DRAINAGE INFORMATION SHEET

RE: CERTIFICATE OF OCCUPANCY APPROVAL FOR RESPOND BUILDING ADDITION
(D-17/D63) REVISION DATED APRIL 6, 1989

DRAINAGE PLAN

LOT 38-A, UNIT IV

PIPE INLET DETAIL
 N.T.S.

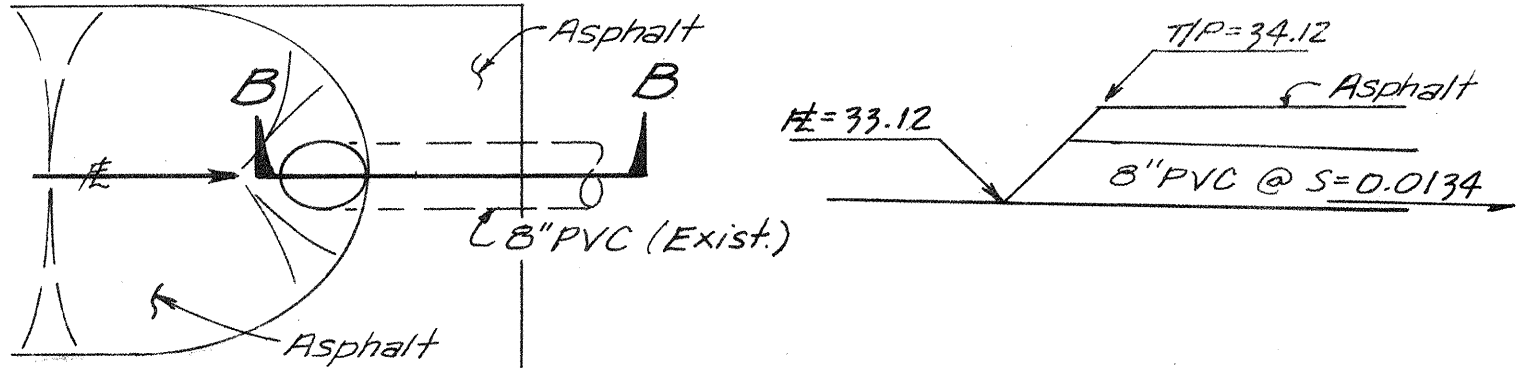
Please advise your client that the final approval will be granted when concurrence is received from the Inspection Section for the pipe penetration through the curb (S.O. #19).
